THE VILLAGE AT BANFIELD WOODS
 PORTSMOUTH, NH

RE: Peer Review #2 of R-Tank Design for The Village at Banfield Woods, Banfield Road, Portsmouth, NH by TF Moran for Green and Company Real Estate, Revised April 29, 2020.

At your request we have completed an independent third party review of design plans and supporting information prepared in support of a certain innovative stormwater treatment system planned near the site entrance to the subject residential development. Specifically, the scope of our review was limited to consideration of design accommodations for a proposed underground stormwater treatment system, to be generally situated beneath Stations 2+00± and 3+00± of a future private roadway intended to provide exclusive access to twenty-two currently planned detached residential dwellings. In keeping with your instructions our review of this planned construction principally focused on assessment of anticipated system performance and constructability. Further, at your request we also contemplated the possible existence of alternate solutions given your site contractor's anticipation of high construction cost associated with furnishing and installing the system as currently p

R-TANKS - PROFILE VIEW
NOT TO SCALE

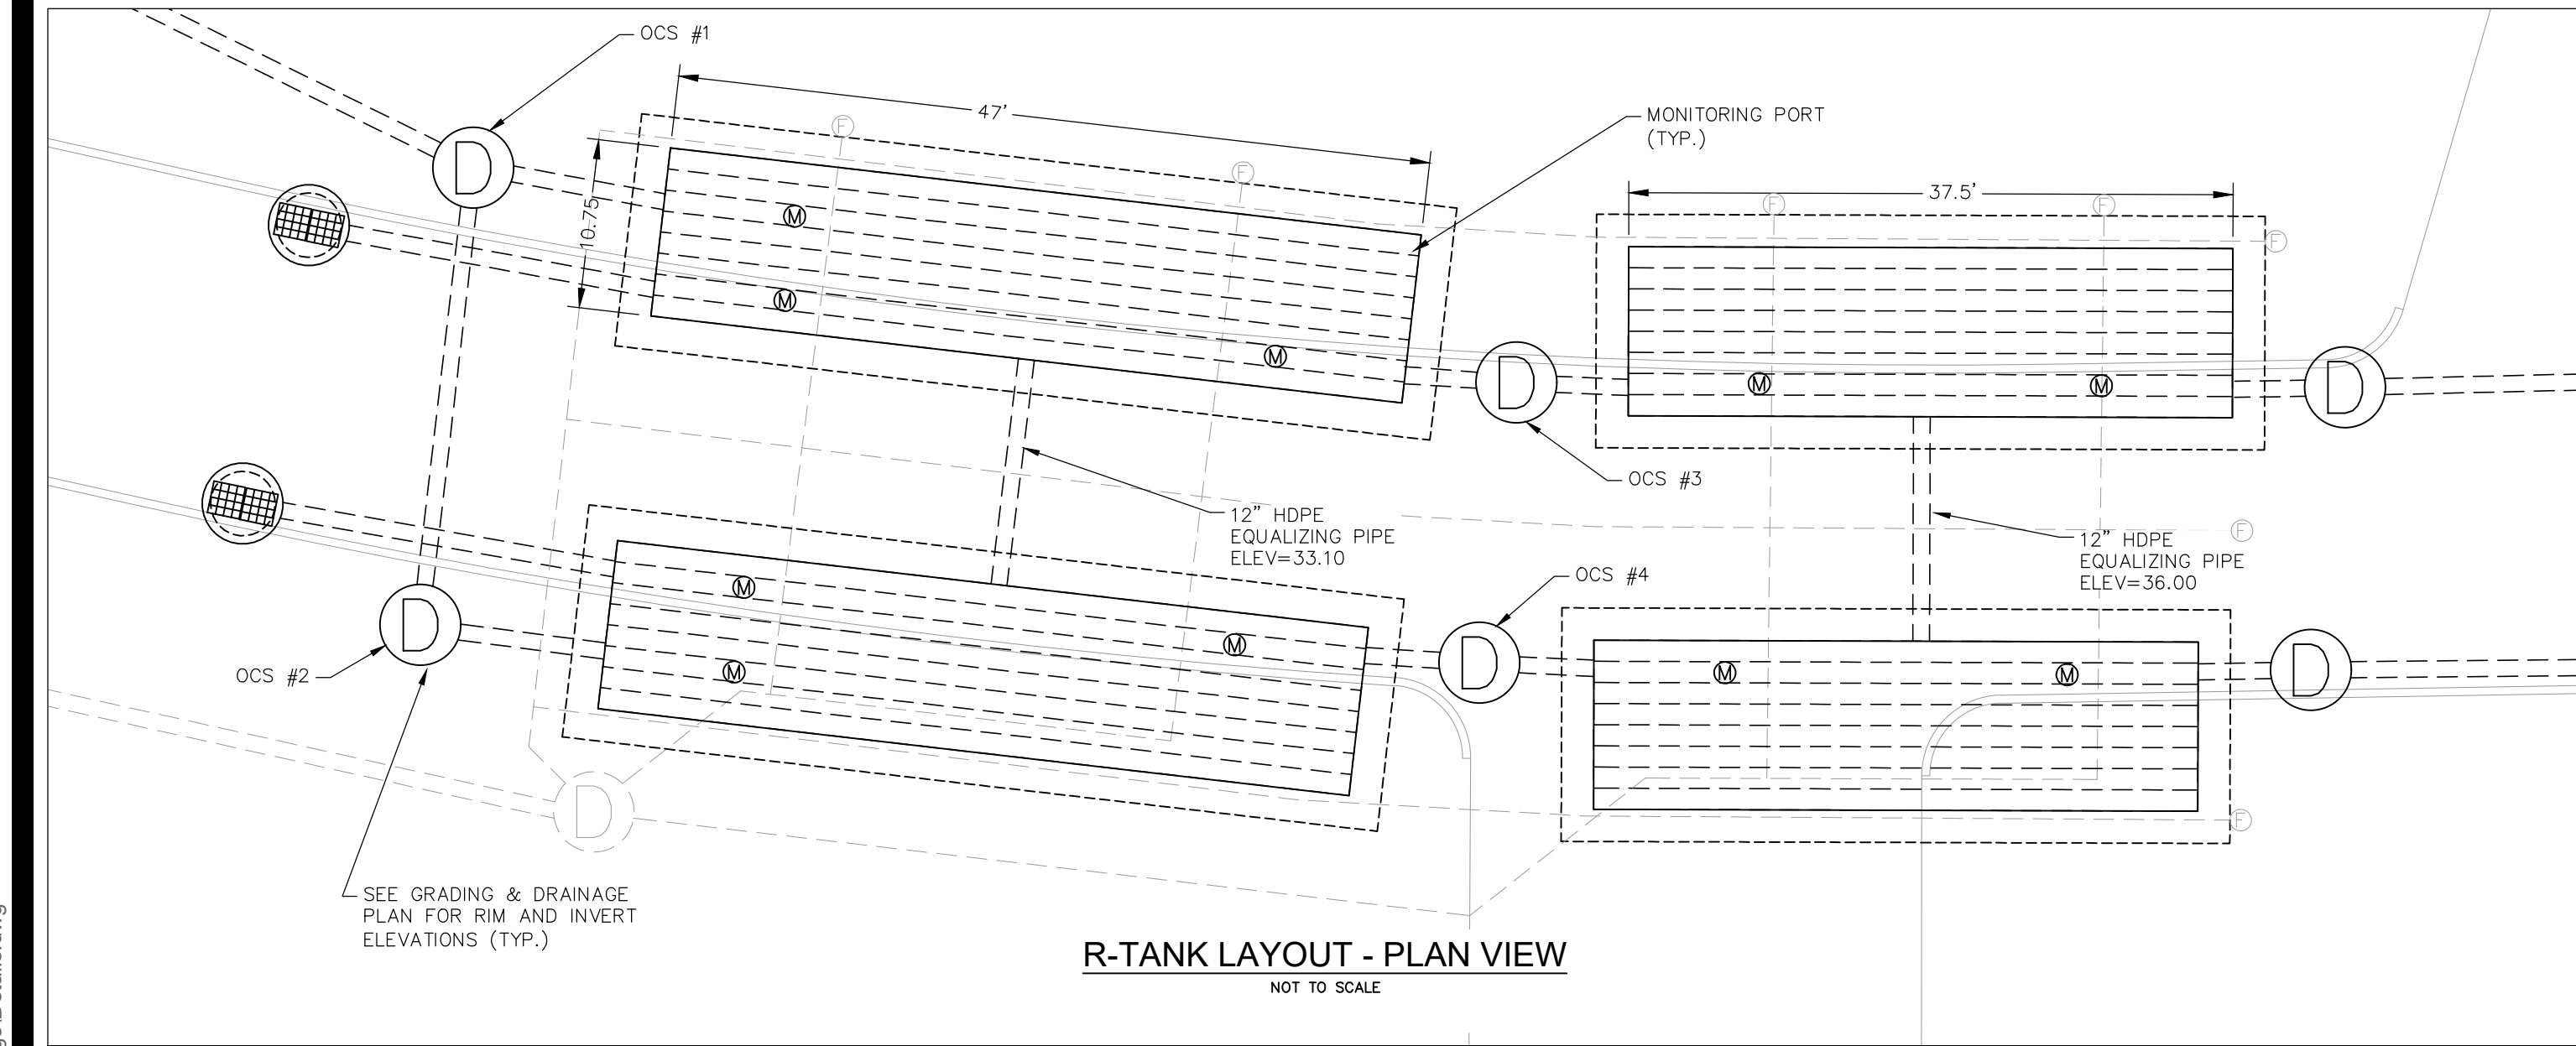
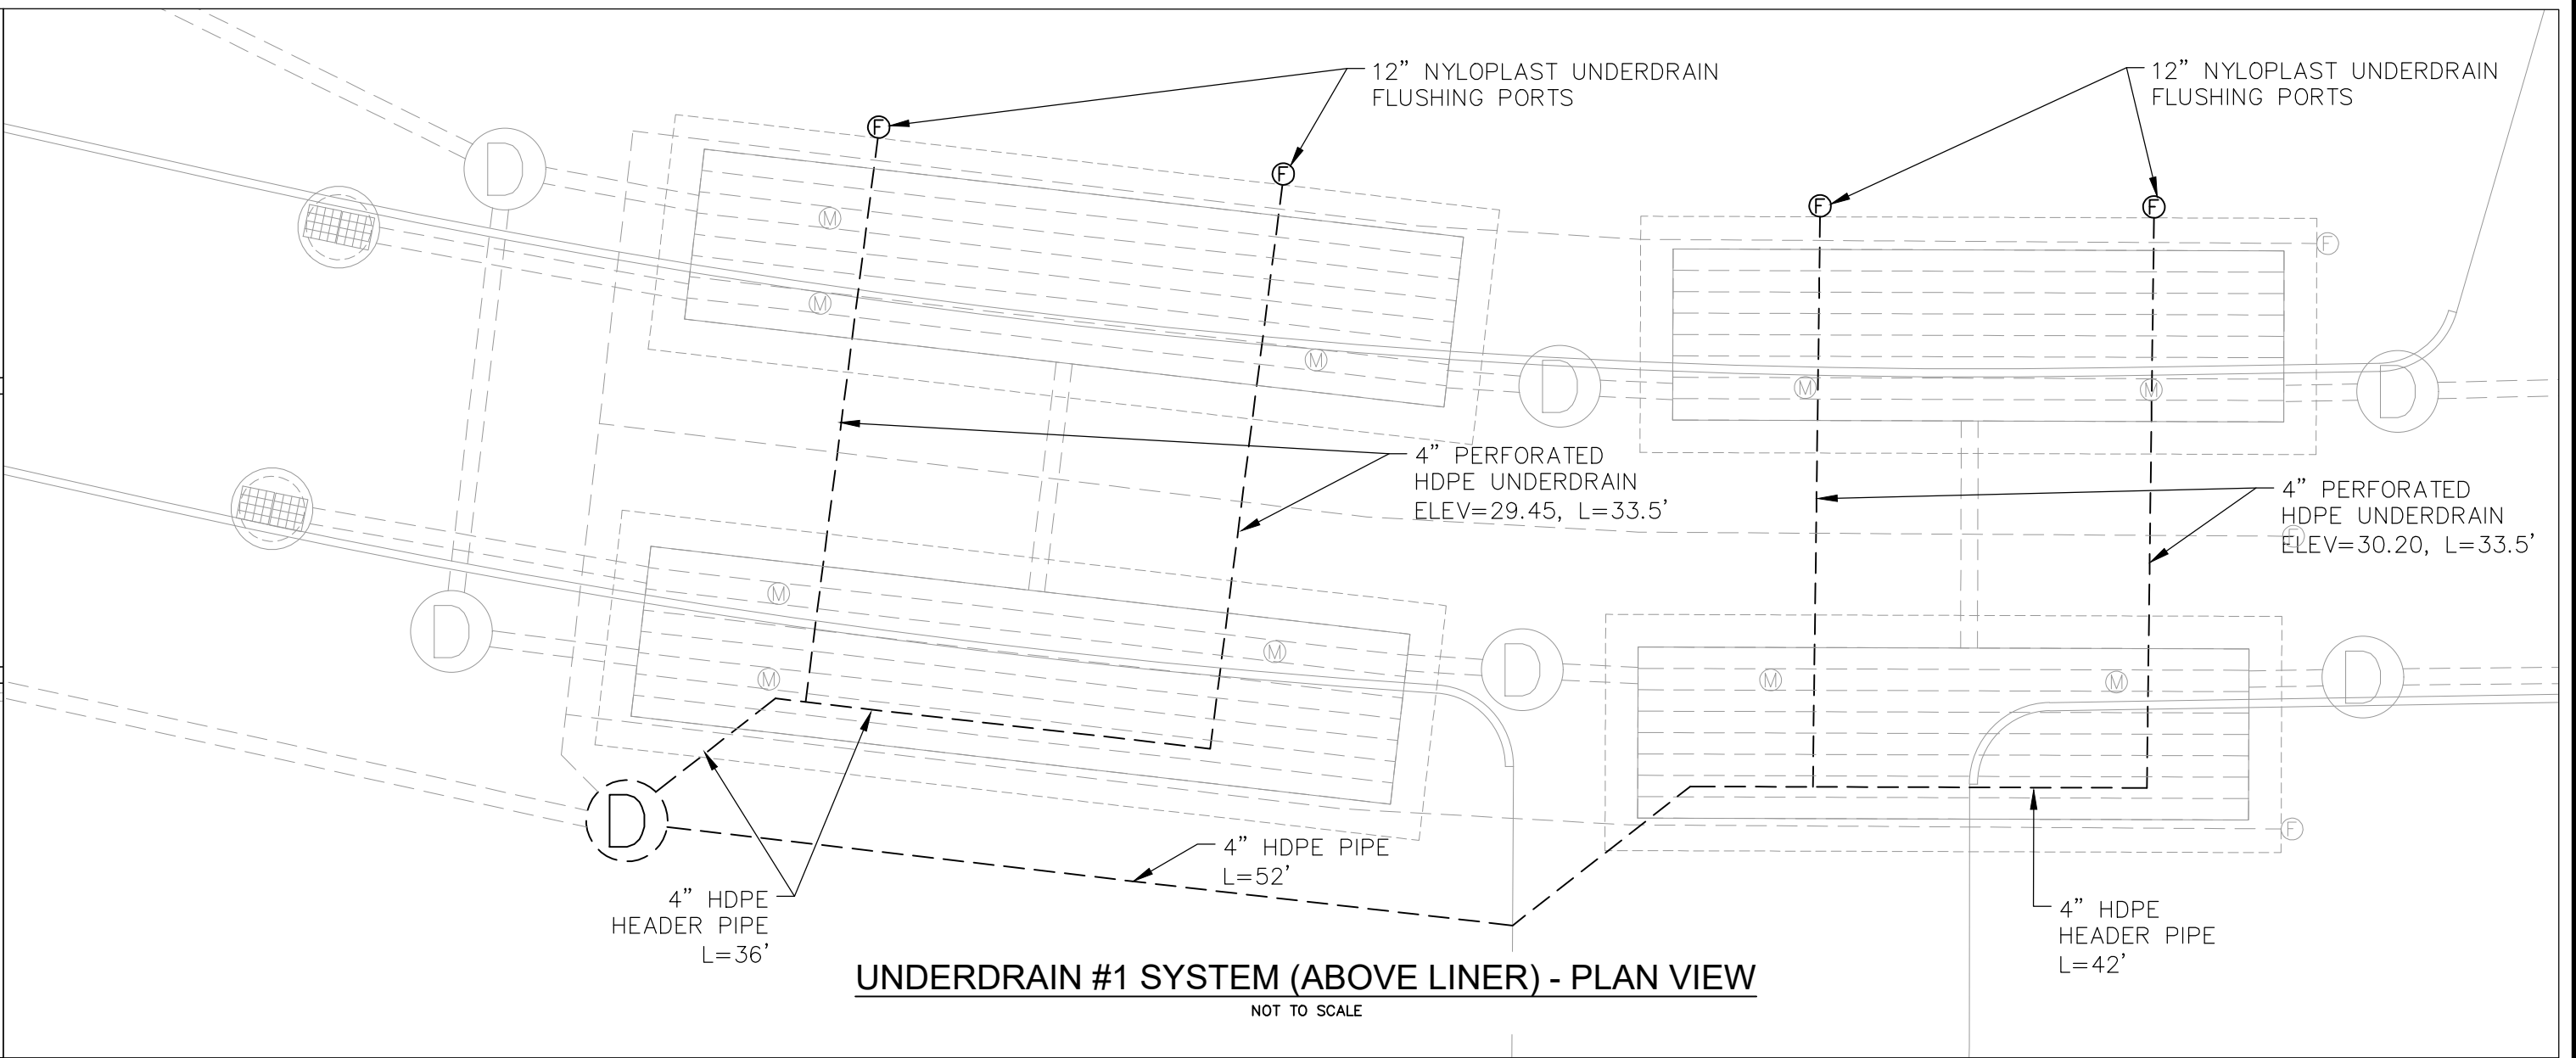
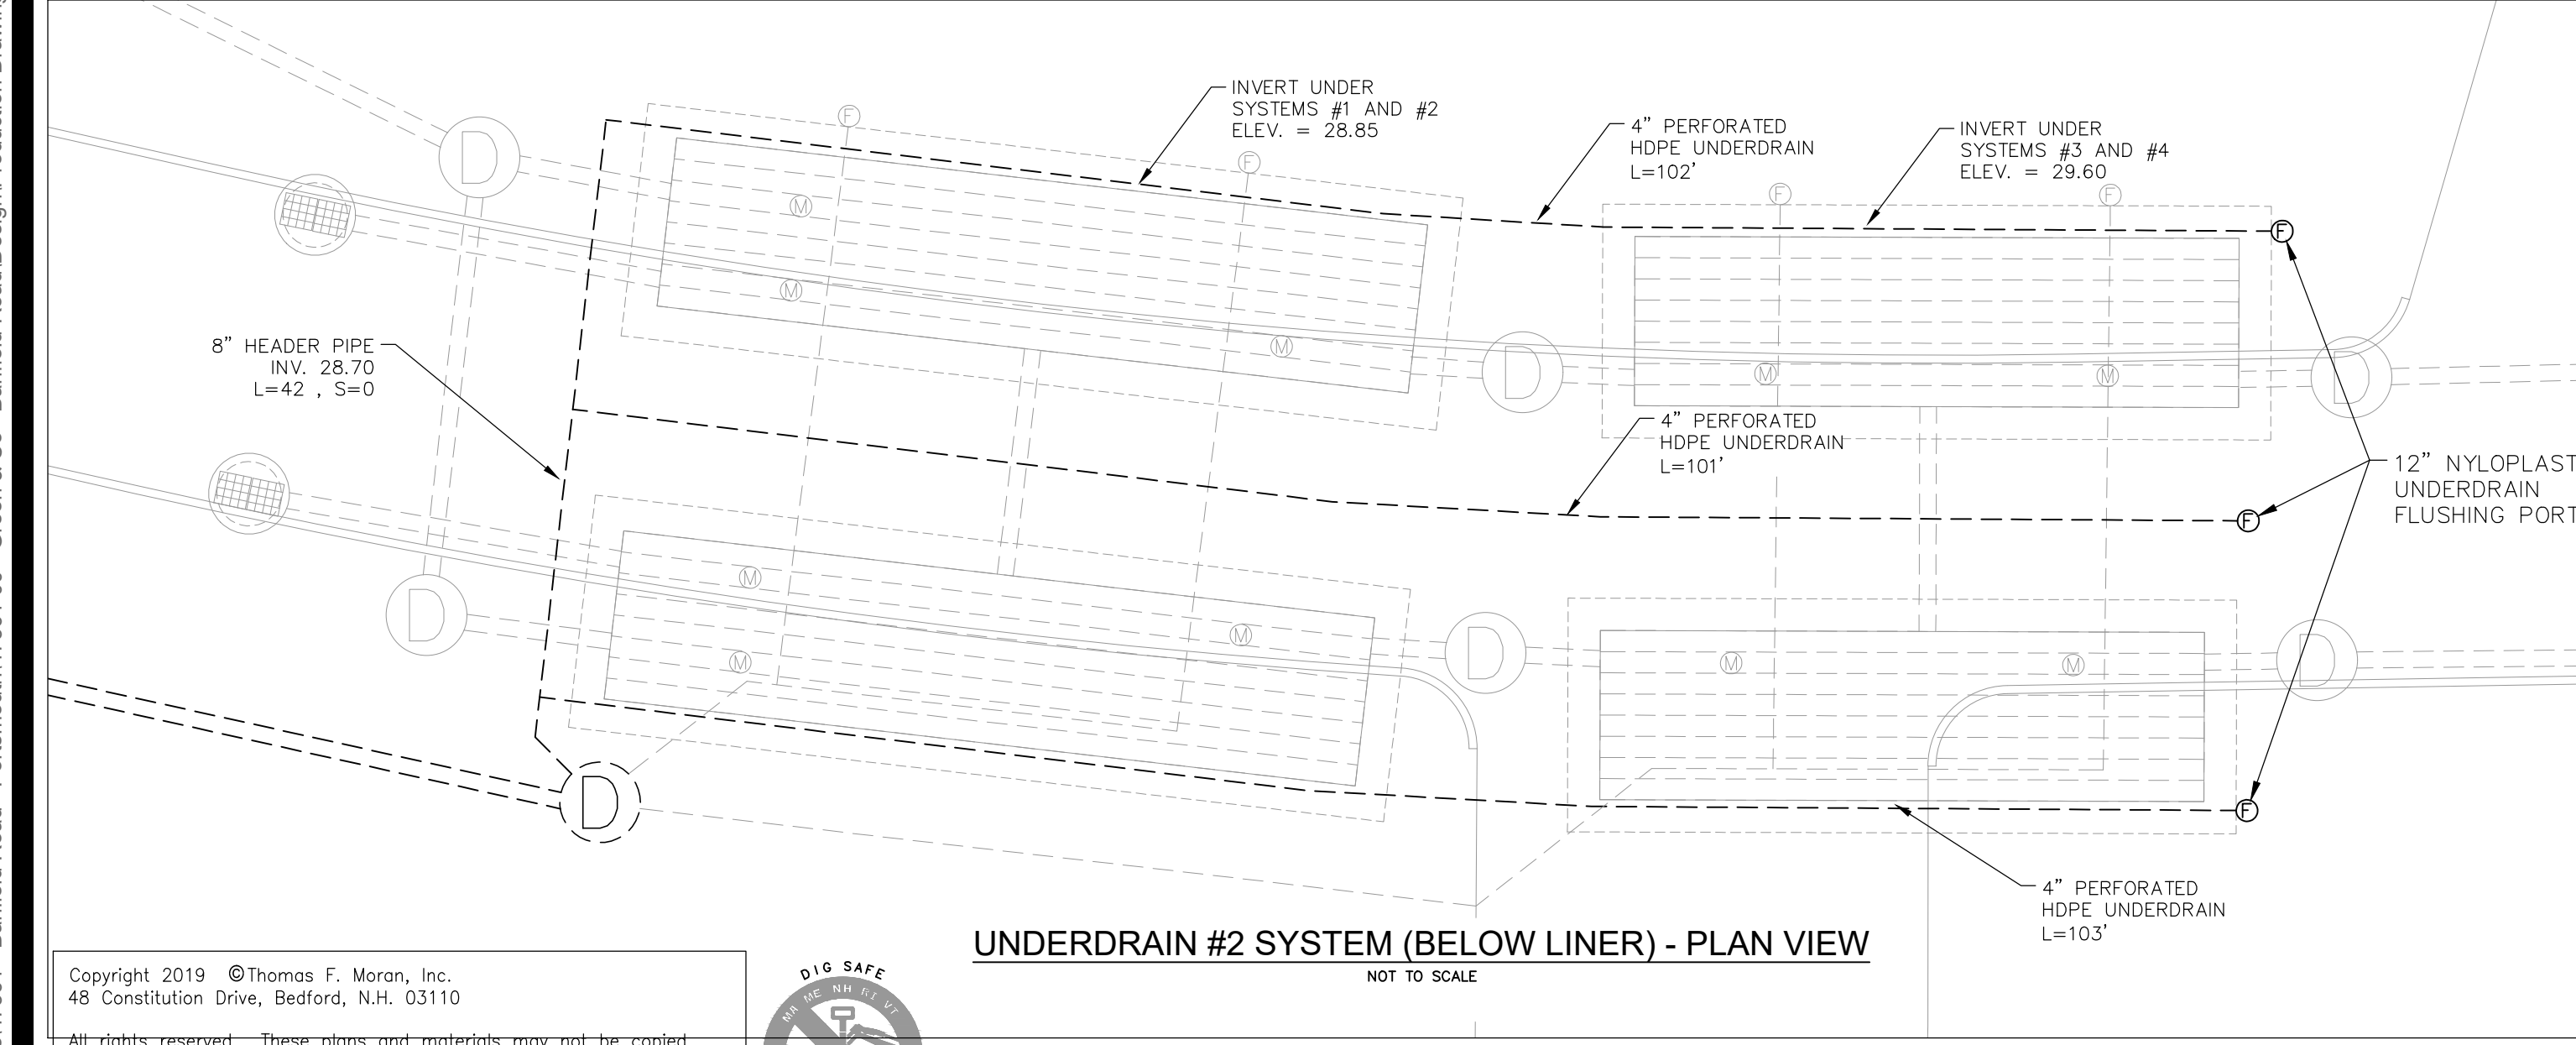
The R-Tank SD used in this application for HS-20 loads require a minimum of 18" of cover and a maximum of 108" to maintain a maximum load bearing capacity 42.9 PSI with a factor of safety ranging from 2.1 to 3.75 respectively. Sheet C-35 appears to detail more than sufficient cover to maintain load bearing capacity.

- Filter course specifications needed.** *Sheet C-35 lists a filter layer at the base of the R-Tanks. I do not see a specification for the filter layer for the subsurface detention and filtration.*
Revision: The filter course is an ASTM C33 sand with less than 2% passing the #200 sieve and is in accord with other designs I have worked with in the past.

- Maintenance ports.** *Sheet C-35 provides a detail for a maintenance port however the locations and number of ports are not detailed in the long-section or on the grading and drainage sheet C-10.*
Revision: The locations and number of ports are now detailed in the long-section on C-39 and on the grading and drainage sheet C-10. There are 2 maintenance ports shown on each R-Tank system with the specific location identified. This allows for proper monitoring of the system.
